Amendments to the Drawings:

REMARKS

Thelen Reid & Priest – Robert E. Krebs
Serial No. 09/510,349
Filing Date: February 22, 2000
TRP Docket No.: 034620-049

FIG. 19
PRIOR ART

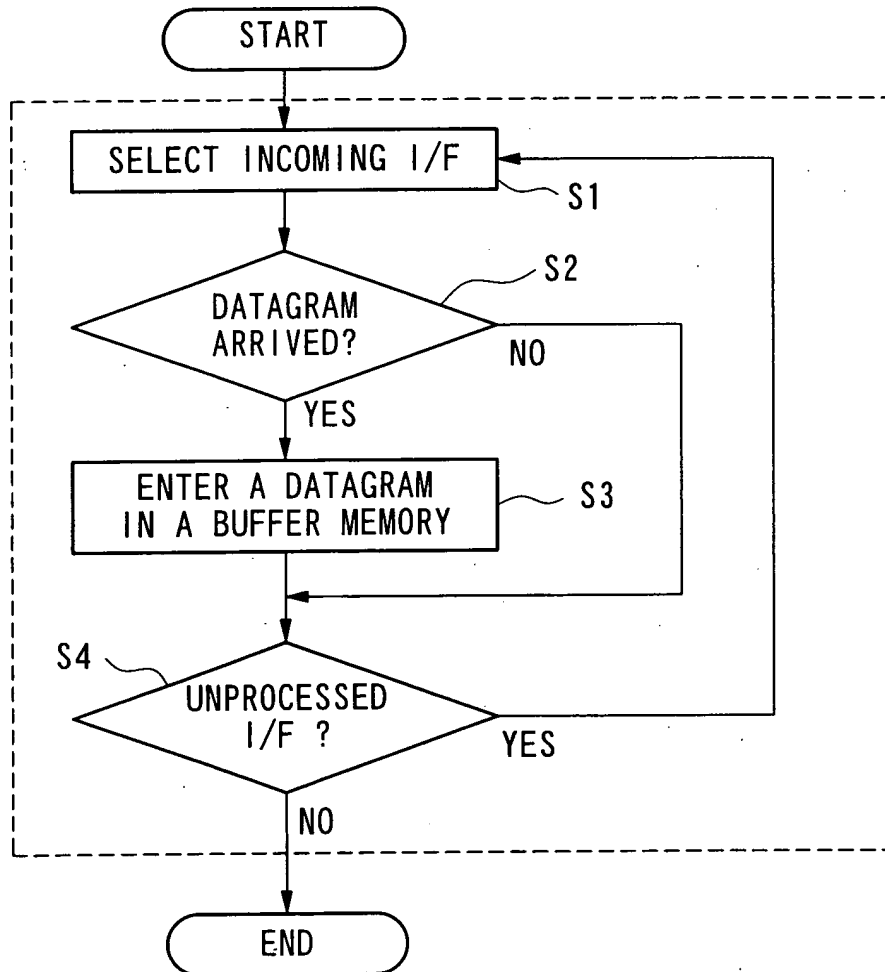
The figures stand objected to because "Figures 19-23 should be designated by a legend such as -- Prior Art --". Figures 19-23 have been amended to include the legend. It is respectfully requested that this objection be withdrawn.

FIGS. 19-23 have been amended to include the legend -- Prior Art --.
